**CITY OF CARMEL-BY-THE-SEA
PLANNING COMMISSION
REGULAR MEETING AGENDA**

November 12, 2014
Wednesday
Tour – 2:30 p.m.
Meeting – 4:00 p.m.

Dennis Levett
Monte Verde 3 NE of 4th
Blk: 32, Lot: 16
APN: 010-222-007</p> | <p>Consideration of Final Design Study (DS 14-72) and associated Coastal Development Permit application for the construction of a new residence located in the Single-Family Residential (R-1) Zoning District</p> |

Sheet Number: **C-1.3**
 of: [Blank] Sheets

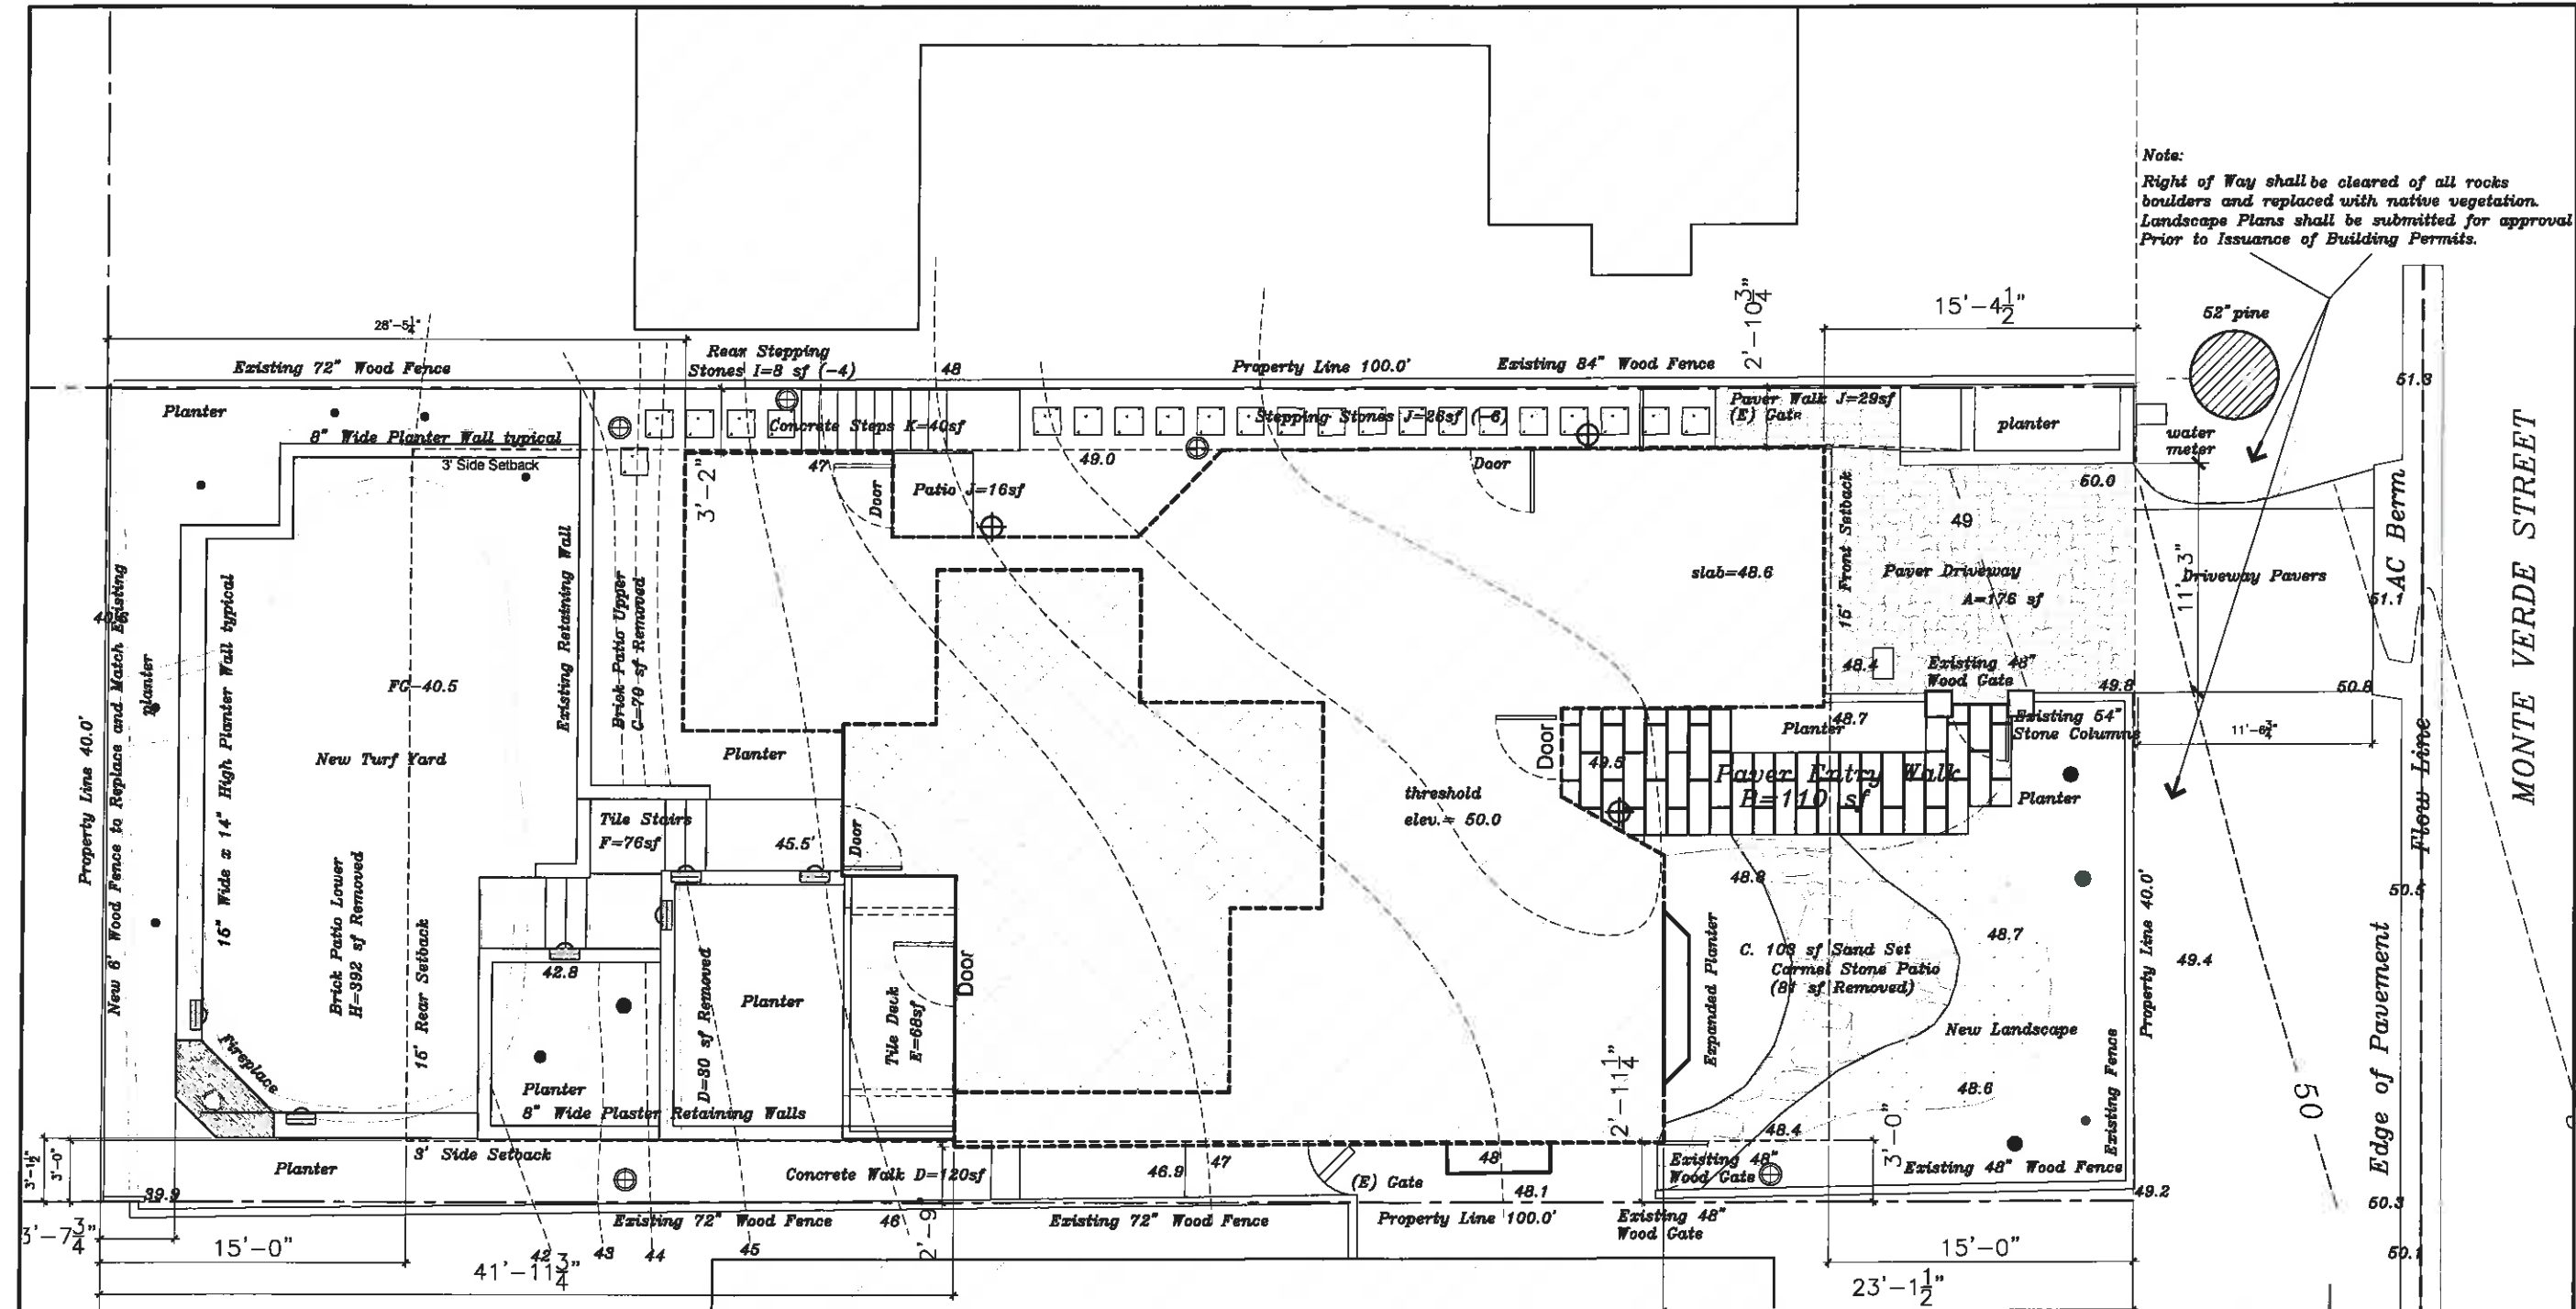
Exterior Lighting: The location of the light fixtures is depicted on the site plan and elevation drawings. In addition, the style and wattage of the light fixtures are shown on Sheet C-1.3 of the plan set. The plan set notes that the wattage will be 25 watts maximum for the wall-mounted fixtures and 15 watts for the path lighting; however, no bulb type, specific wattage, or

lumen level is noted. This should be clarified by the applicant and noted on the construction plan set. A condition of approval has been drafted to address this requirement.

25.	With regard to the light fixtures, the applicant shall include the specific bulb type, wattage, and lumen level on the construction plan set.	✓
26.	Prior to final inspection, the applicant shall remove the existing encroachments from the City ROW including the rocks and boulders.	✓

Sheet Number: **L-1.1**
 of: Sheets

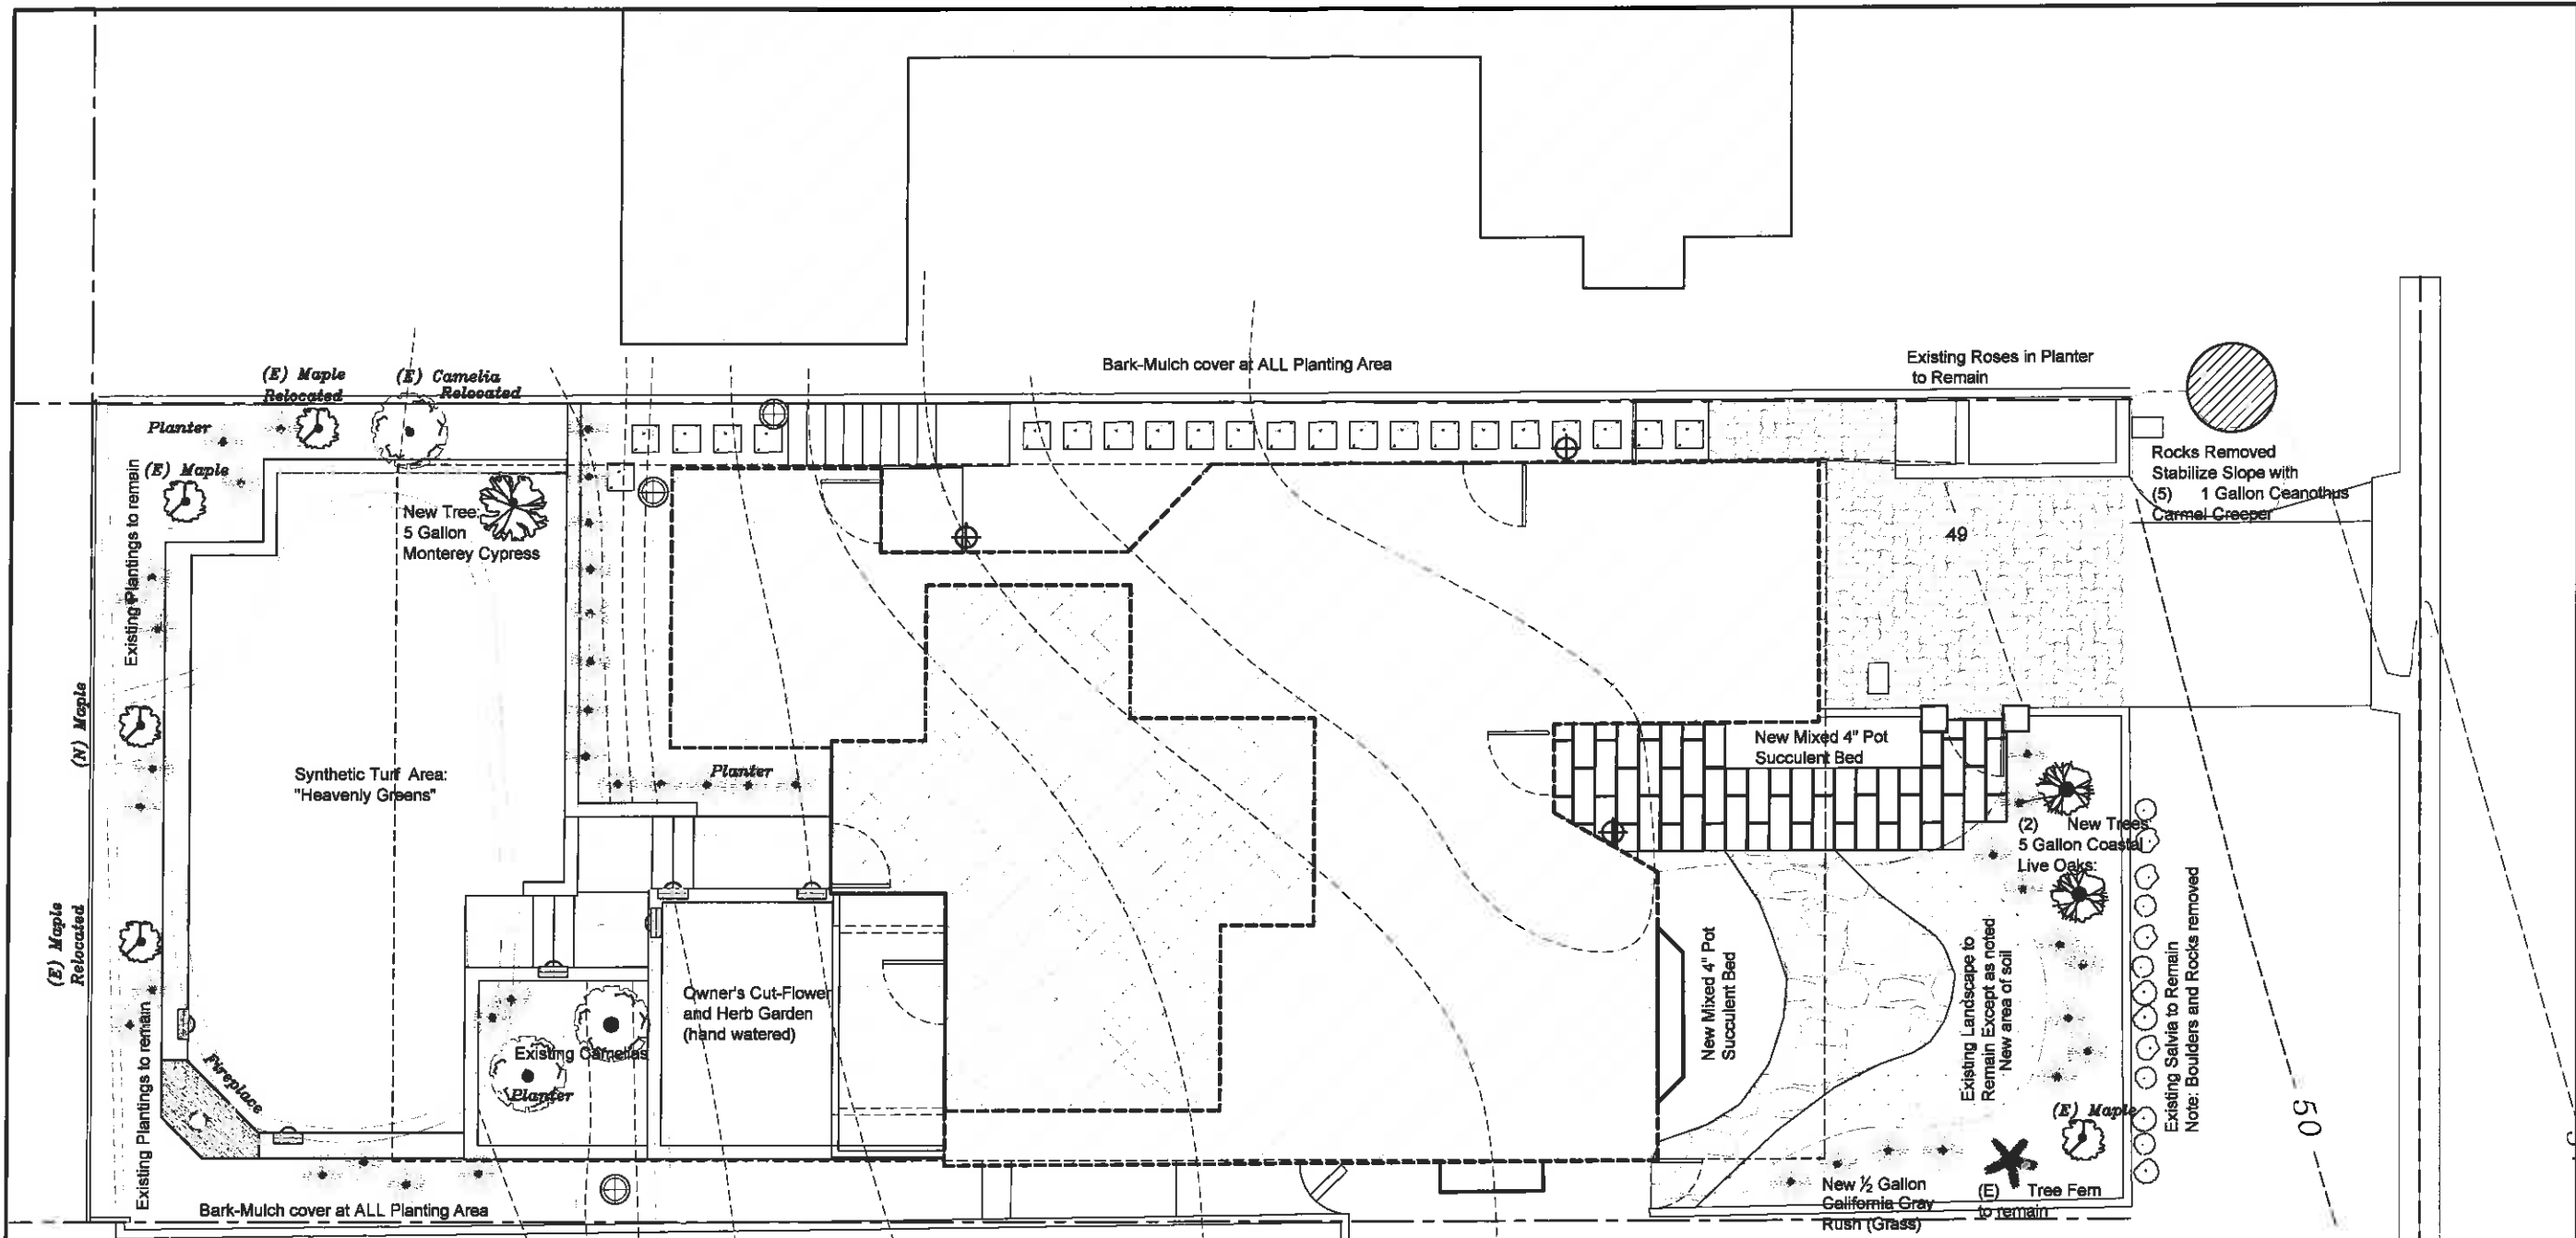
Analysis: The applicant has provided a landscape plan on Sheet L-1.1 of the plan set that proposed two new lower-canopy oak trees at the front of the property and one new upper-canopy tree at the rear. A condition has been drafted to ensure installation and maintenance of these trees.

22.	The applicant shall plant and maintain two new lower-canopy trees and one new upper-canopy tree of substantial size and caliber and of a species approved by the City Forester. The location, size, and species of these trees shall be noted on the plan set submitted with the Building Permit application. Prior to final inspection, the trees shall be planted. These trees should be located approximately 10 feet from any building.	✓

FIGURE 1

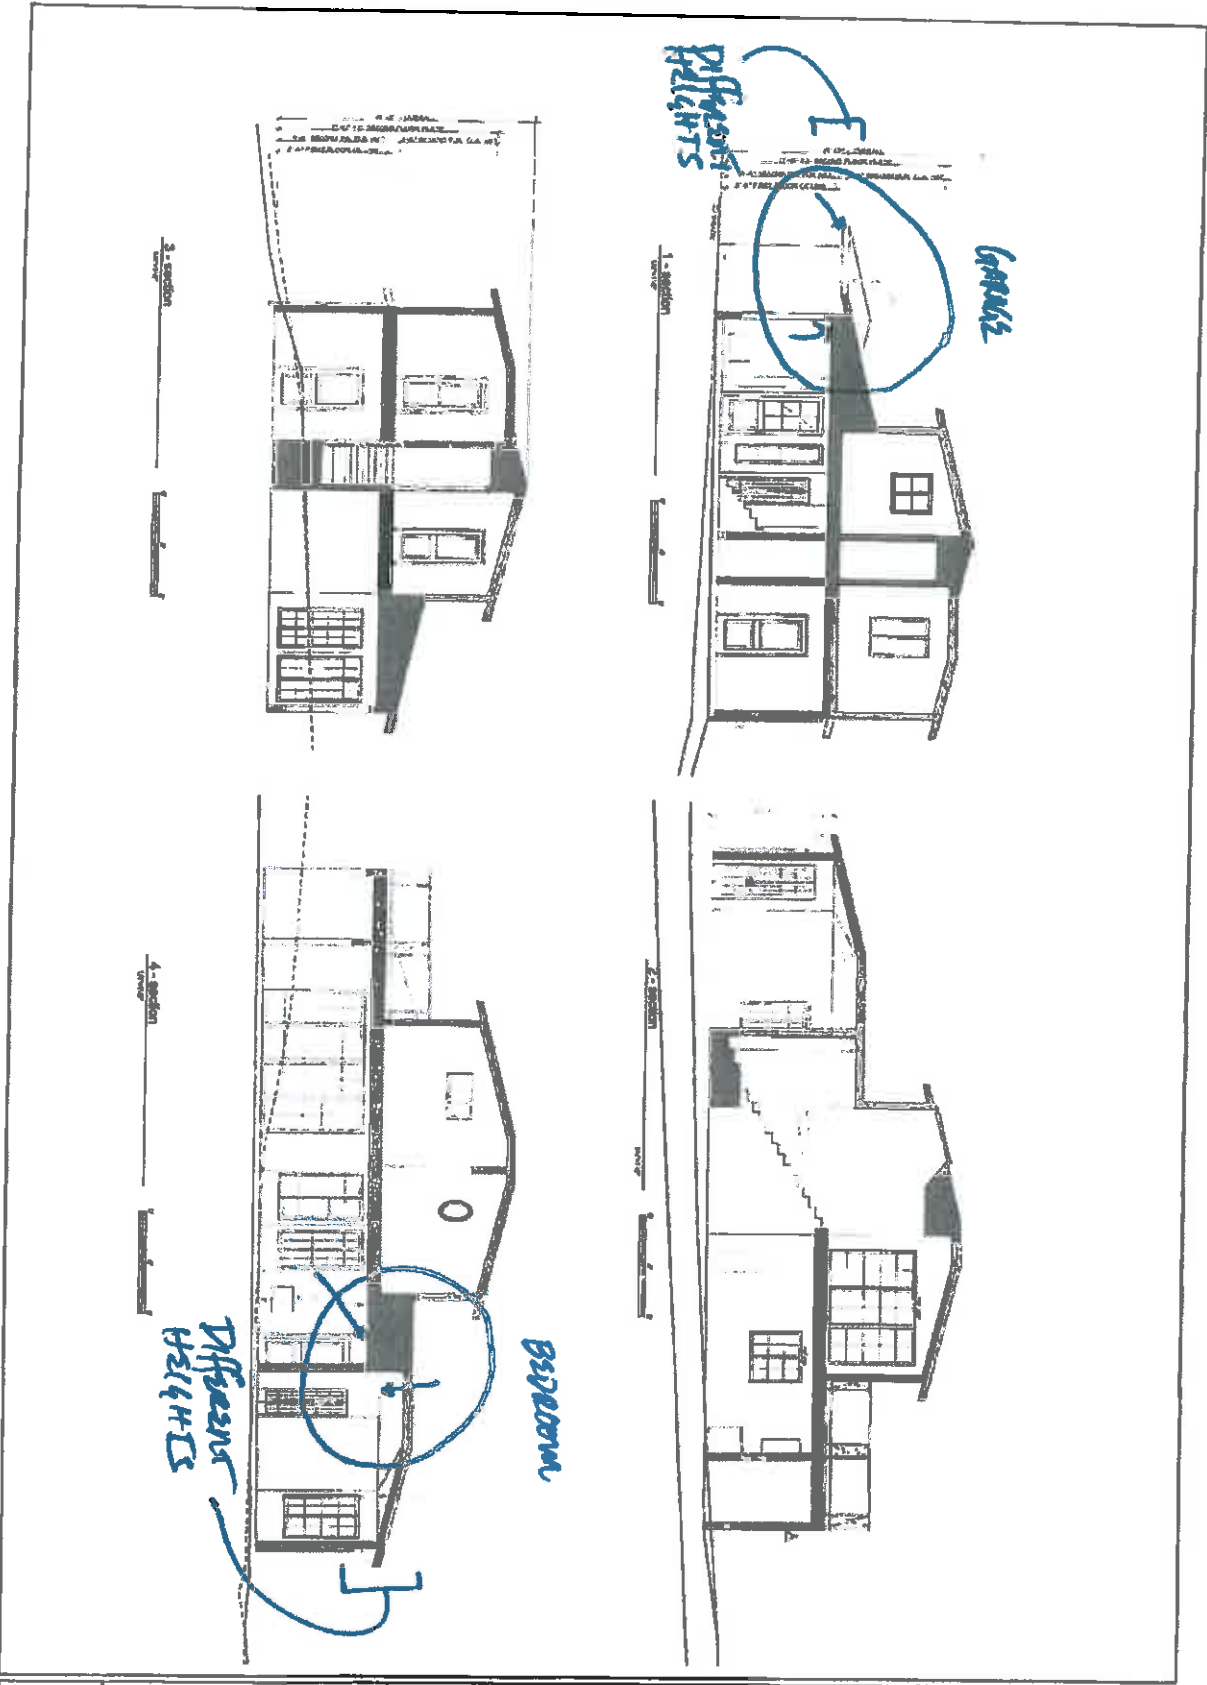
The ridge heights are primarily a consequence of the plate heights of the two first floor structures that impact the views, notwithstanding the 3" in 12" slope of the roof. These plate heights are unusually high on any basis.³ The unusually tall plate heights can be seen on page 13 of the applicant's submission, which page is reproduced with notes added as Figure 1, attached hereto (delivered as a separate pdf file).

- A simple modification to frame the bedroom and garage the same height as the rest of the house, which is the traditional method for houses, and framing the walls with a standard 8’ plate, also removes the obstruction by lowering the ridge height 18”. This modification will bring the bedroom and garage in to the same height and scale of the rest of the house, thus, in fact, improving the continuity of the design. See Figure 2 attached hereto (delivered as a separate pdf file) for an illustration of how this may be accomplished with minimal effort.
